Environmental and Ecological Planning Advisory Committee

The 5th Meeting of the Environmental and Ecological Planning Advisory Committee
June 17, 2021

ARVA PUMPING STATION TO HURON STREET WATER TRANSMISSION MAIN ENVIRONMENTAL IMPACT STUDY, MAY 20, 2021 BY AECOM

Reviewed S. Heuchan, S. Levin, and K. Moser

Figure 1: Locations of (from left to right) Chamber 12 MAIN, Chamber 12A and Chamber 13. The red pins show locations of chambers.

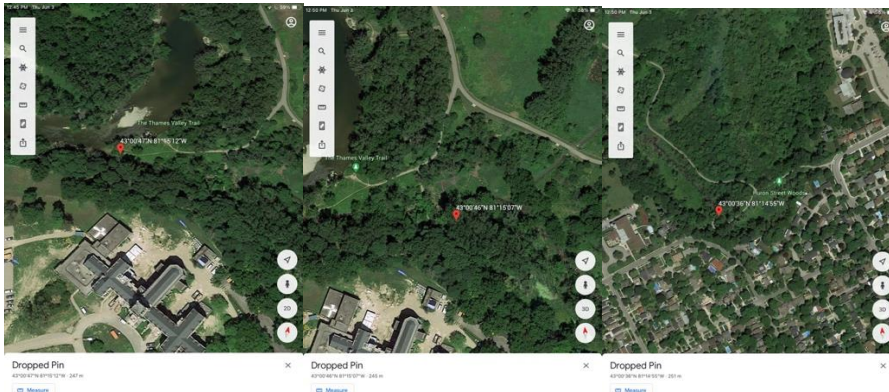
Attached are Google Earth images of where we think these chambers are located. The first is no more than 20-30m from the Thames. The first photograph after the maps shows the site. We believe this is Chamber 12 MAIN and is not correctly shown on the AECOM map contained in the EIS. The second site (chamber 12A) is at the base of the hill that heads up to the seminary. It is off the trail and in mature trees. The second map and second photo show the site. It appears that Chamber 12A is located approximately correctly and chamber 13 is correct on the AECOM map. The last photo shows an invasive Iris located just adjacent to the chamber 12A site. <https://www.ontario.ca/page/yellow-iris>.

RECOMMENDATION J: The EIS show the correct locations of each chamber.

RECOMMENDATION K: Replanting native trees or other native plants in “beat up” area to the east of chamber 12 Main.

Photo of yellow irises proximal to Chamber 12A.

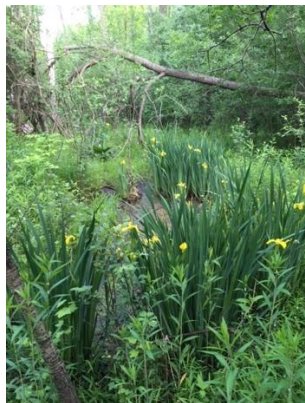
RECOMMENDATION L: If the **invasive yellow iris** cannot be removed now, its removal must be included in the work that takes place.
